## Tips & Tricks – All Models

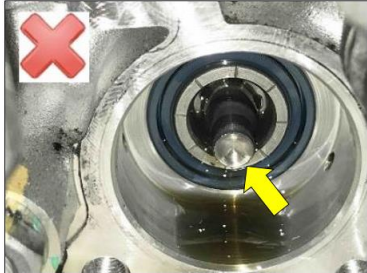
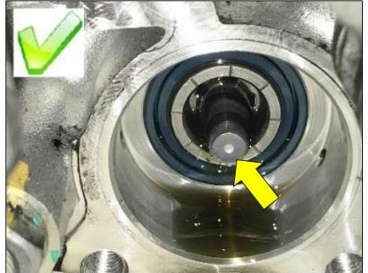
| no. | Symptom                                                                                                                                                                         | Subject       | Photo                                                                                | Notes and Indications - Corrective action                                                                                                                                                                                                                                                                                                                                                                                                                                                                                                                                                                                                                                                                                                                                                                                                                                                                                                                                                                                                                                                                                                           |
|-----|---------------------------------------------------------------------------------------------------------------------------------------------------------------------------------|---------------|--------------------------------------------------------------------------------------|-----------------------------------------------------------------------------------------------------------------------------------------------------------------------------------------------------------------------------------------------------------------------------------------------------------------------------------------------------------------------------------------------------------------------------------------------------------------------------------------------------------------------------------------------------------------------------------------------------------------------------------------------------------------------------------------------------------------------------------------------------------------------------------------------------------------------------------------------------------------------------------------------------------------------------------------------------------------------------------------------------------------------------------------------------------------------------------------------------------------------------------------------------|
| 1   | <p><u>ONLY</u><br/><u>Monster 821</u><br/><u>Monster 1200</u><br/><u>SuperSport</u></p> <p>Possible engine popping sound during deceleration and/or irregular idling</p>        | Airbox        |    | <p>We have received some complaints about a possible engine popping sound during deceleration. The performed analyses have shown that this symptom could be caused by an incorrect installation of the throttle bodies in the relevant intake manifolds (possible deformation of the rubber profile).</p> <p>Therefore, if you find any similar symptoms, we kindly ask you to check the correct installation of the Airbox on the motorcycle and that:</p> <ul style="list-style-type: none"><li>- throttle bodies are correctly inserted inside rubber intake manifolds, along the whole perimeter;</li><li>- the rubber profile of the intake manifolds is not deformed.</li><li>- the 2 fastening ties are correctly positioned in the seat on the intake manifolds.</li></ul> <p>Please be reminded that, to make throttle body insertion easier on rubber intake manifolds, the use of silicone lubricant or similar product is absolutely necessary.</p> <div></div> |

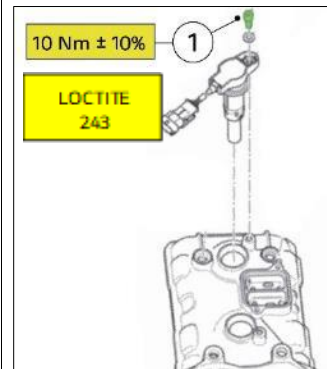
| no. | Symptom                                                                                                                                                                                 | Subject                  | Photo                                                                              | Notes and Indications - Corrective action                                                                                                                                                                                                                                                                                                                                                                                                                                                                                                                                                                                                                                                                                                                                                                                                                                                                                                                                                                                                                                                                                                                                                                                                                                                                                                                                                                                                                        |
|-----|-----------------------------------------------------------------------------------------------------------------------------------------------------------------------------------------|--------------------------|------------------------------------------------------------------------------------|------------------------------------------------------------------------------------------------------------------------------------------------------------------------------------------------------------------------------------------------------------------------------------------------------------------------------------------------------------------------------------------------------------------------------------------------------------------------------------------------------------------------------------------------------------------------------------------------------------------------------------------------------------------------------------------------------------------------------------------------------------------------------------------------------------------------------------------------------------------------------------------------------------------------------------------------------------------------------------------------------------------------------------------------------------------------------------------------------------------------------------------------------------------------------------------------------------------------------------------------------------------------------------------------------------------------------------------------------------------------------------------------------------------------------------------------------------------|
| 7   | <p><u>ONLY</u><br/><u>models equipped with</u><br/><u>hydraulically controlled</u><br/><u>clutch lever</u></p> <p>Possible reduction of the clutch fluid level inside its reservoir</p> | Hydraulic clutch control |  | <p>We received a few claims concerning a reduction of the clutch fluid level inside its reservoir. We would like to inform you that it is not sufficient to carry out the bleeding procedure or top up the clutch fluid inside the reservoir. We suggest, at a preliminary stage, to check:</p> <ul style="list-style-type: none"> <li>the play between the clutch master cylinder and the lever</li> <li>if the clutch pushrod is worn or damaged in the area of contact with the clutch slave cylinder (ball)</li> <li>the condition of the clutch slave cylinder protective diaphragm, which must not be torn.</li> </ul> <p>According to our analyses, this phenomenon is due to a DOT4 leakage from the primary seal of the clutch slave cylinder (missing fluid in the reservoir builds up in-between the clutch slave cylinder diaphragms); in some cases, this phenomenon is also accompanied by wear of the clutch pushrod. We therefore ask you to replace the slave cylinder with a new <b>part no.19540091D</b> featuring a new gasket in order to prevent the phenomenon described above.</p> <p>If the clutch pushrod is damaged as shown in the figure, replace it as well.</p> <div style="display: flex; justify-content: space-around; align-items: center;">   </div> |

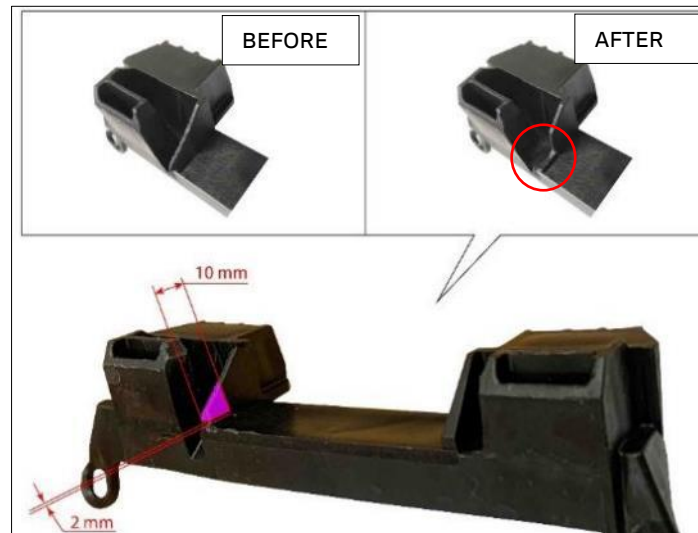
| no. | Symptom                                                                                                                      | Subject                       | Photo                                                                              | Notes and Indications - Corrective action                                                                                                                                                                                                                                                                                                                                                                                                                                                                                                                                        |
|-----|------------------------------------------------------------------------------------------------------------------------------|-------------------------------|------------------------------------------------------------------------------------|----------------------------------------------------------------------------------------------------------------------------------------------------------------------------------------------------------------------------------------------------------------------------------------------------------------------------------------------------------------------------------------------------------------------------------------------------------------------------------------------------------------------------------------------------------------------------------|
| 1   | <p><u>ONLY</u><br/><u>Diavel Lamborghini</u></p> <p>Possible indentation of RH and/or LH outer cover of the air conveyor</p> | RH and LH air conveyor covers |  | <p>We have received some isolated reports about a possible indentation of the RH and/or LH outer cover of the air conveyor.</p> <p>To avoid this phenomenon, it is necessary to position <b>washer (1)</b> 4x14x1 Part no.85240171A between <b>outer cover (2)</b> and carbon air <b>conveyor (3)</b> in the upper fixing point, as shown in the figure.</p> <div data-bbox="1140 440 2107 1050">   </div> |

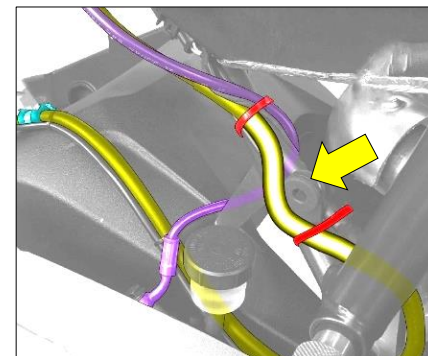
| no. | Symptom                                                                                                     | Subject        | Photo                                                                              | Notes and Indications - Corrective action                                                                                                                                                                                                                                                                                                                                                                                                                                                                                                                                                                                                                                              |
|-----|-------------------------------------------------------------------------------------------------------------|----------------|------------------------------------------------------------------------------------|----------------------------------------------------------------------------------------------------------------------------------------------------------------------------------------------------------------------------------------------------------------------------------------------------------------------------------------------------------------------------------------------------------------------------------------------------------------------------------------------------------------------------------------------------------------------------------------------------------------------------------------------------------------------------------------|
| 17  | <p><u>ONLY</u><br/><b><u>Panigale V4R</u></b></p> <p>Introduction of clutch housing with deep anodizing</p> | Clutch housing |  | <p>We have received some isolated reports of possible clutch slipping, due to clutch housing indentation, which does not allow the drive and driven plates to come back into contact with each other correctly. This phenomenon depends on the use of the motorbike and the user, therefore for racing use we suggest replacing the plates approximately every 5000km,.</p> <p>We would like to inform you that the new clutch housing with deep anodizing <b>part no.19810671C</b>, replacing the natural grey one, is available as a spare part; this treatment improves the reliability of the clutch housing reducing the damaging of the drive plates on its contact surface.</p> |

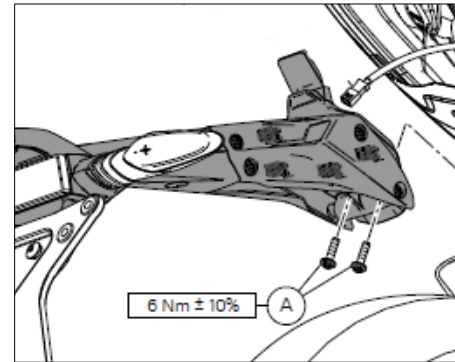
| no. | Symptom                                                                | Subject                                           | Photo                                                                                | Notes and Indications - Corrective action                                                                                                                                                                                                                                                                                                                                                                                                         |
|-----|------------------------------------------------------------------------|---------------------------------------------------|--------------------------------------------------------------------------------------|---------------------------------------------------------------------------------------------------------------------------------------------------------------------------------------------------------------------------------------------------------------------------------------------------------------------------------------------------------------------------------------------------------------------------------------------------|
| 6   | Possible breakage of the rear bank RH heat guard                       | Rear bank RH heat guard<br>part no.4601G351B      |  | <p>We have received some isolated reports of a crack in the rear bank RH heat guard at the retaining screw, as shown in the figure.</p> <p>We would like to inform you that the spare part warehouse has been inspected and only includes the new conforming components; the part number has not changed so, in case of breakage, it is possible to replace it under warranty with a new part no.4601G351B which avoids the above phenomenon.</p> |
